NEVILLE HOUSE SUBDIVISION

APPLICATION NUMBER 6 DATE September 18, 2003
APPLICANT Neville House Subdivision
REQUEST Subdivision

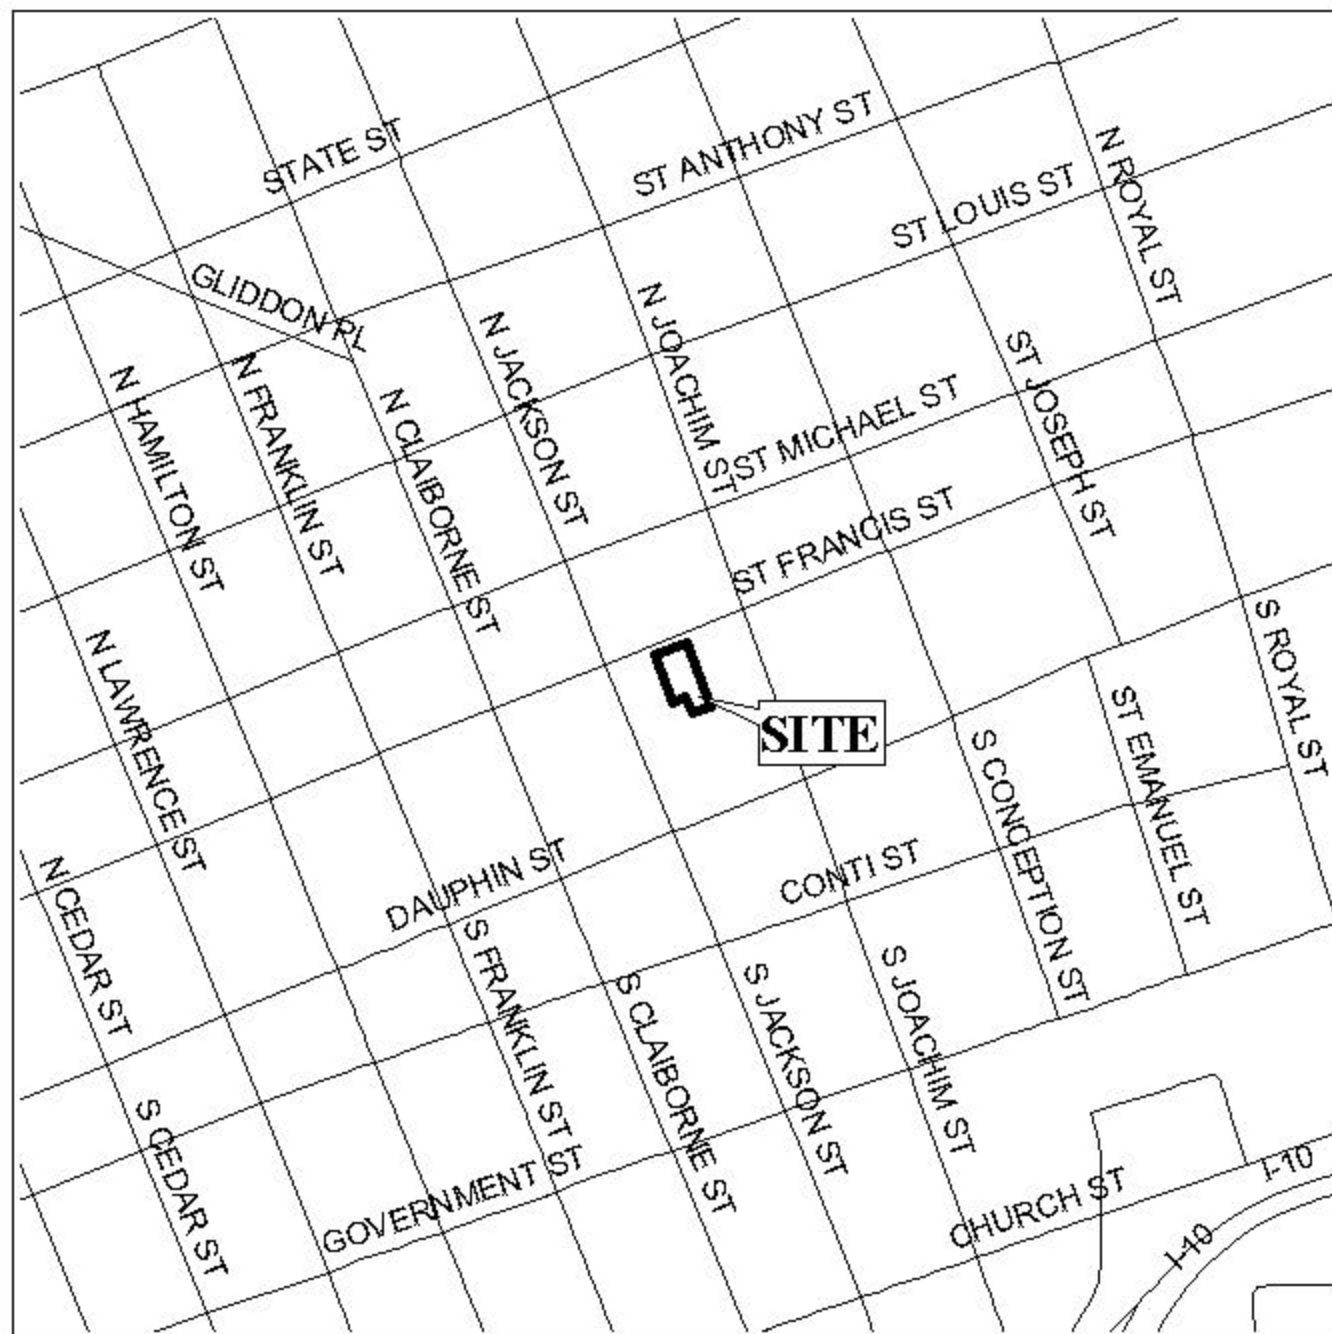
As a means of access management, the placement of a note on the final plat stating that the site is to share a curb cut should be required. In addition, the submission of an Administrative PUD would be required as the site has a common driveway and parking.

As proposed, Lot 1 would have 7,113 square feet of area and Lot 2 would have 2,553 square feet of area; in B-4 districts, there is no minimum area requirement for building sites; therefore, a waiver of Section V.D.2. would be required and recommended for the proposed lot sizes.

Additionally, Lot 1 would exceed the width to depth ratio of the Subdivision Regulations; therefore, a waiver would be required.

With a waiver of Section V.D.2. and V.D.3., the plat will meet the minimum requirements of the Subdivision Regulations and is recommended for Tentative Approval subject to the following conditions: 1) the submission of an Administrative PUD for the shared access and parking.
